Access Compliance Report

Public Rights-of-Way

(Curb Ramps)

Intersection ID: 16872	Main Street: TRYON_ST	Cross Street: PRESSLEY_RD	Location: NW
ADA ID: 41BFF03247E4	Ramp Type: BlendTrans2	Initial Pass/Fail: Fail	Overall Compliance: No
Codes/Mitigation Info/Possible Solution		Field Measurements/Component Compliance	
Severity Score: 21.25

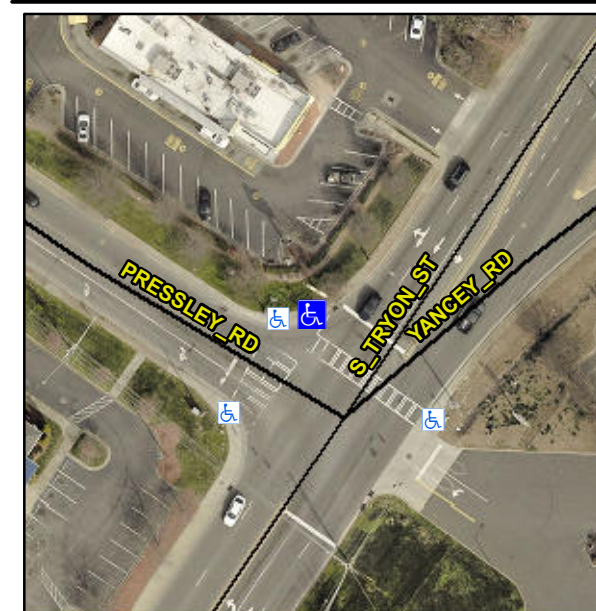
Not Found, R304.5.1, R304.5.3

Compliance	Description	Data	Compliance	Description	Data
N/A	Ramp Length (in)	71.0	Yes	BlendTrans Slope (%)	2.7
No	Ramp Width (in)	45.5	No	BlendTrans XSlope (%)	6.1
N/A	Flare Type LT	N/A	N/A	Flare Type RT	N/A
N/A	Flare Slope LT (%)	N/A	N/A	Flare Slope RT (%)	N/A
N/A	Flare Traversable LT?	N/A	N/A	Flare Traversable RT?	N/A
N/A	Landing Length (in)	N/A	N/A	DWS Provided?	N/A
N/A	Landing Width (in)	N/A	N/A	DWS Contrast?	N/A
N/A	Landing Slope (%)	N/A	N/A	DWS Length (in)	N/A
N/A	Landing X Slope (%)	N/A	N/A	DWS Full Width?	N/A
N/A	Landing Curb? (Y/N)	N/A	N/A	DWS Offset (in)	N/A
N/A	Shared Landing?	N/A			
N/A	Gutter Ponding?	N/A	N/A	Gutter Slope (%)	N/A
N/A	Gutter Lip Ht (in)	N/A	N/A	Gutter X Slope (%)	N/A
N/A	Painted X Walk1?	Yes	N/A	Painted X Walk2?	N/A
	X Walk 1 Direction	To SE		X Walk 2 Direction	N/A
	X Walk 1 Width (in)	109.0		X Walk 2 Width (in)	N/A
	X Walk 1 Slope (%)	2.7		X Walk 2 Slope (%)	N/A
	X Walk 1 X Slope (%)	3.2		X Walk 2 X Slope (%)	N/A

N/A	Ramp inside XWalk1?	Yes	N/A	Ramp inside XWalk2?	N/A
	Road Slope (%)	3.2		Clear Space?	N/A
	Road X Slope (%)	2.7	N/A	Clear Space to XWalk (in)	N/A
N/A	Any Obstructions?	N/A	N/A	Storm Grate/Utility Hazard?	N/A
	Obstruction Type			Storm Grate/Utility Type	
		N/A			N/A
			Yes	Surface Condition? (G/P)	Good
			No	Curb Slope (%)	6.5

Remove & Replace Curb Ramp With Two New Directional Ramps or Equivalent.
